Bulletin No. TB-12-002
Issue/Revision: 1
Prepared By: Chris Martin
Approved By: Tim Moore

Subject: WSM 6 – Connector Label

5W Male Connector

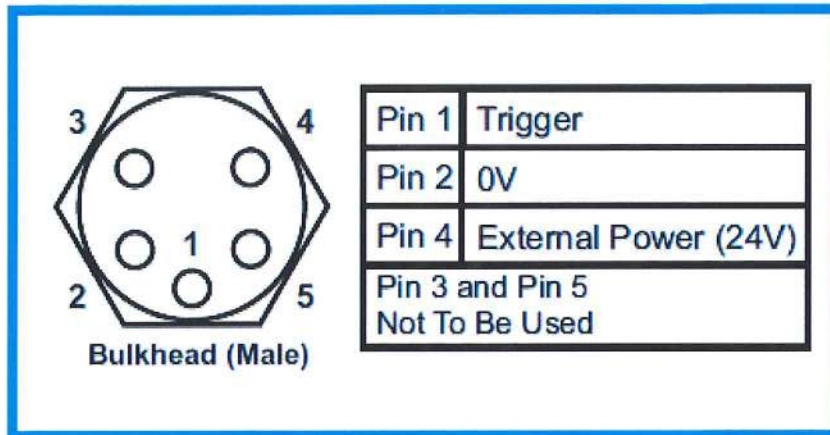
The pin numbering diagrams on the WSM6 label for the 5-way male and female bulkhead connectors have been reversed. The wiring table is correct, as is the information and illustration in the Product Manual.

The labels should look as follows:

The updated label should be stuck over the top of the existing connector diagram; it is a waterproof self-adhesive label. The existing label should be cleaned and degreased in the relevant area using a suitable product. The backing paper on the supplied replacement label should be carefully peeled back, and the label itself stuck over the existing connector illustration.
